Apex Site

Engineering Report for Pond 2 Final Closure

August 17, 2003

Figure 5
Selected Cover System Alternative Profile

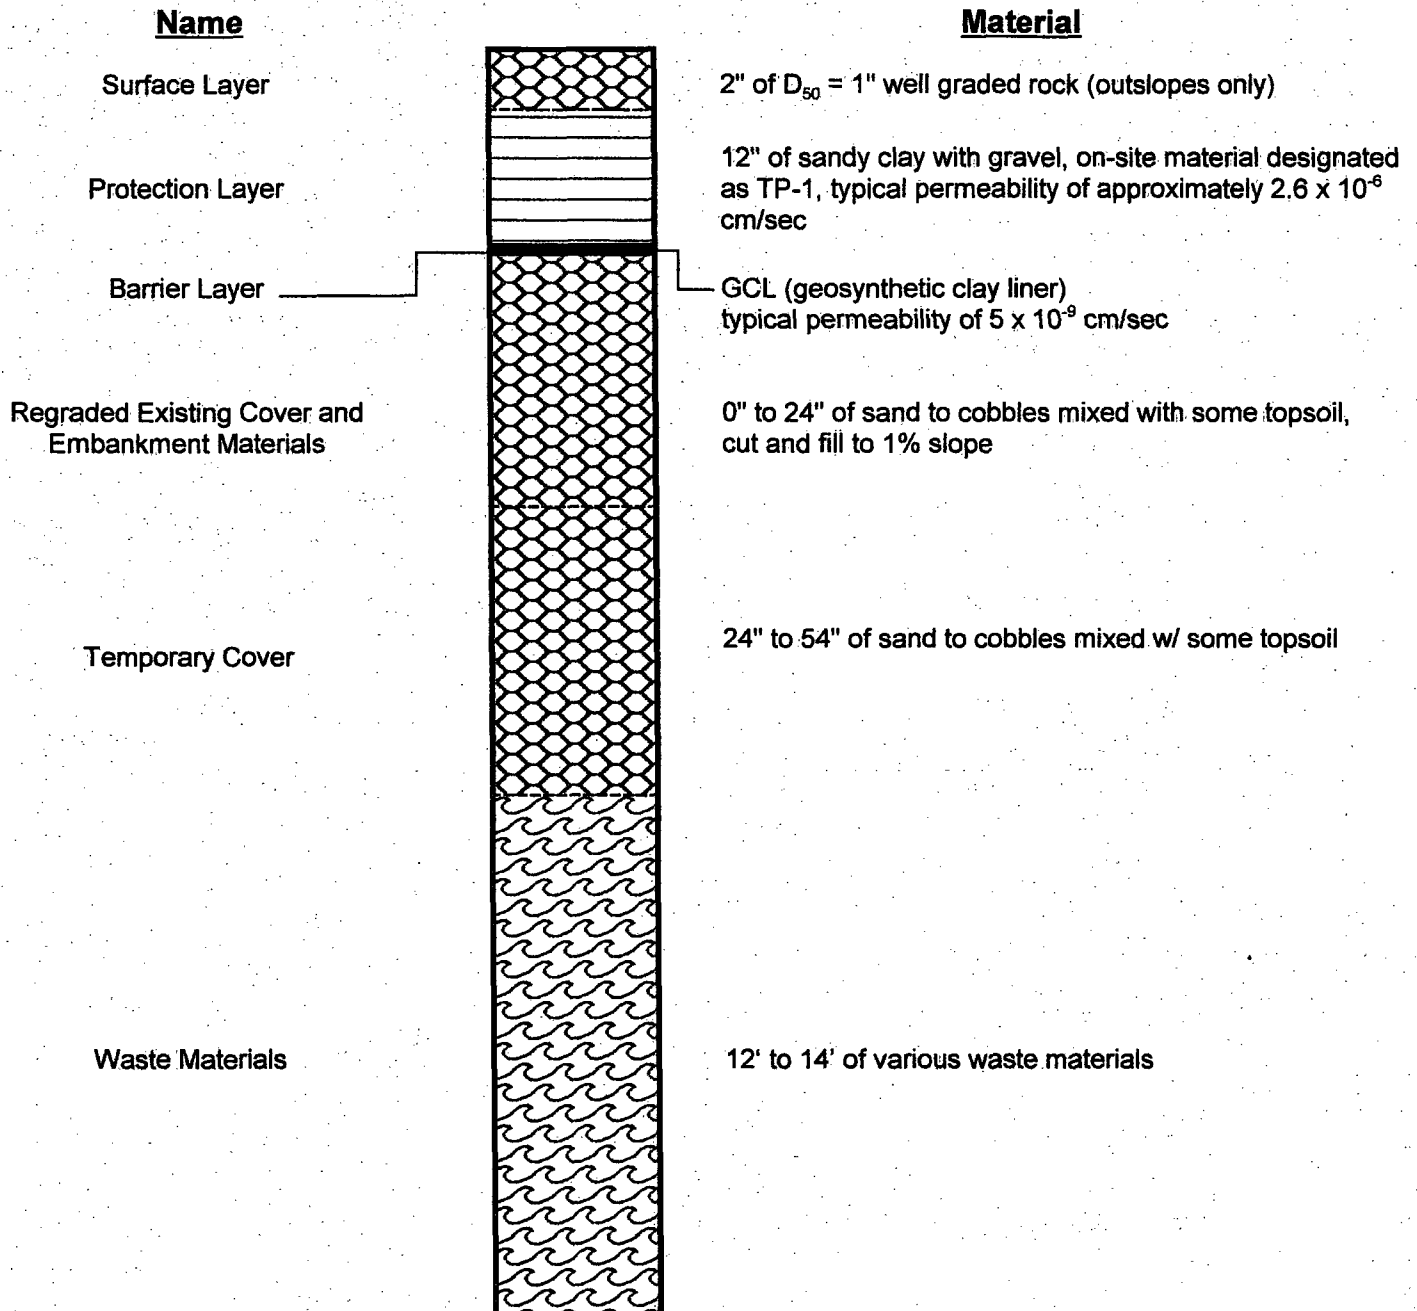
In Volume I, Section 3.2.3 Alternative 2 (GCL) - Selected Alternative Cover System, page 12, How can Hecla better stabilize the embankment side slopes if bentonite becomes hydrated? Why isn't there any surface layer protection on the top cover areas (the outslopes will have a 2 inch thick layer of 1-inch rock)?

In Volume I, Section 4.4.3 Surface Layer Placement, page 20, A surface layer consisting of at least 2- inches thick of 1-inch rock should also be incorporated on the top surface for superior long-term erosion protection from wind and/or rainfall (see comment re: Section 4.4.4)..

Figure 12
Borrow Area / Diversion Channel Excavation Profiles

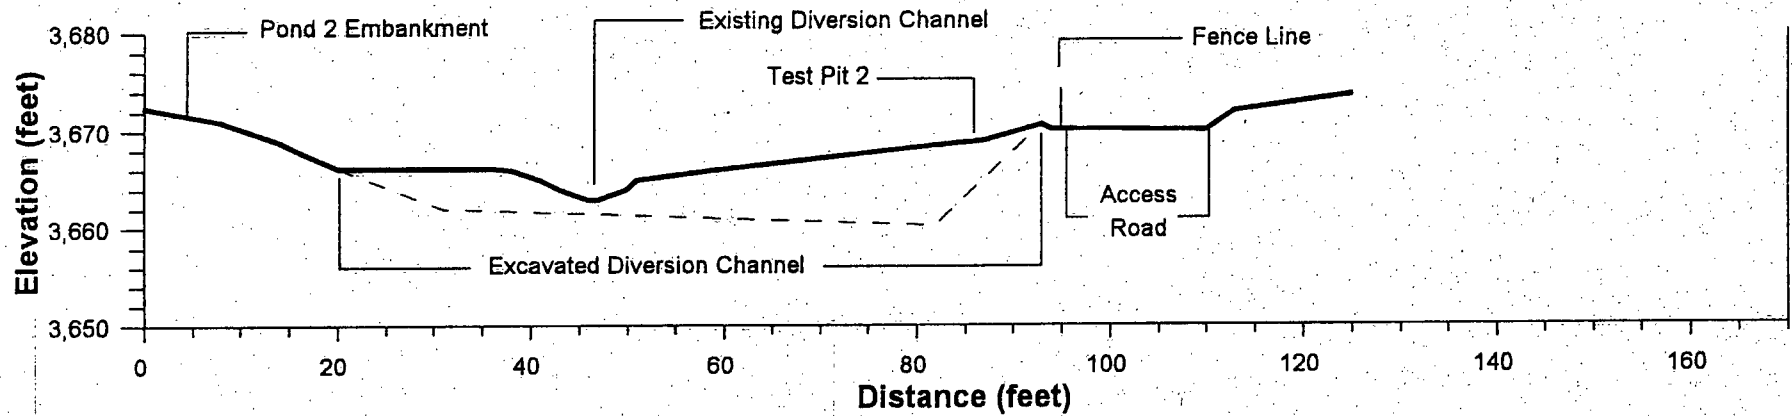
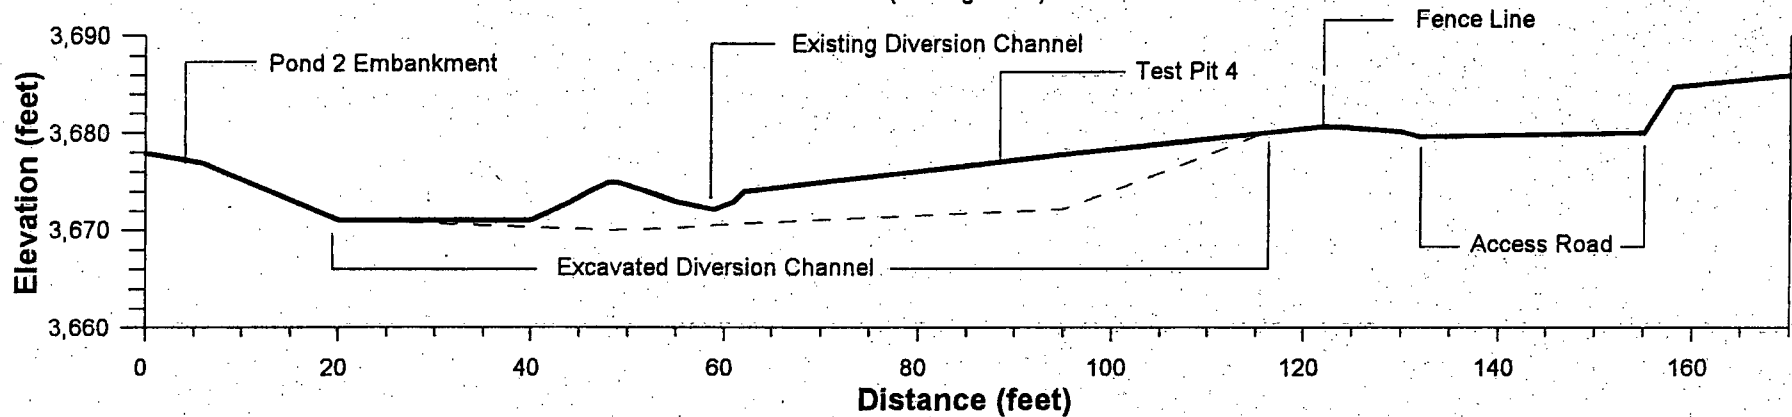
In Volume I, Section 4.4.4 Diversion Channel Erosion Protection Placement, page 21, A 24 hour, 100-year storm event should be calculated to design runoff and erosion protection of the diversion channel (and final cover system). If greater peak flow results from using the 24 hour, 100-year storm event vs. the proposed 6-hour, 25 year design, then this figure should be used to ensure greater stability and erosion control.
